### Office Action Summary

10/572,184

## **DETAILED ACTION**

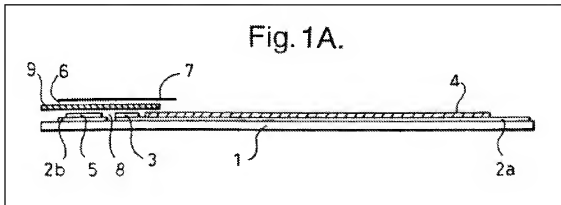
Regarding claim 1, WILLIAMS teaches a sensor comprising at least a first and a second electrode (see conductive layer 2b comprising the first electrode; conductive layer 2a comprising the second electrode) and a volume there between for receiving a liquid sample (see non-conducting gap 8) and which includes an agent that lyses cells (see col. 4 lines 35–38 discussing monofilament mesh 6 being coated with a lysing agent). See figure 1a below. WILLIAMS, however, does not teach the lysing agent being comprised in the first electrode.

Regarding claim 3, WILLIAMS teaches the sensor also comprising a spreading layer over at least the first electrode (see monofilament mesh 6). See figure 1a above.

Regarding claim 4, WILLIAMS teaches the sensor wherein a lysing agent is comprised in a layer applied onto the first electrode (see col. 4 lines 35–40; col. 5 lines 45–51; figure 1a above).
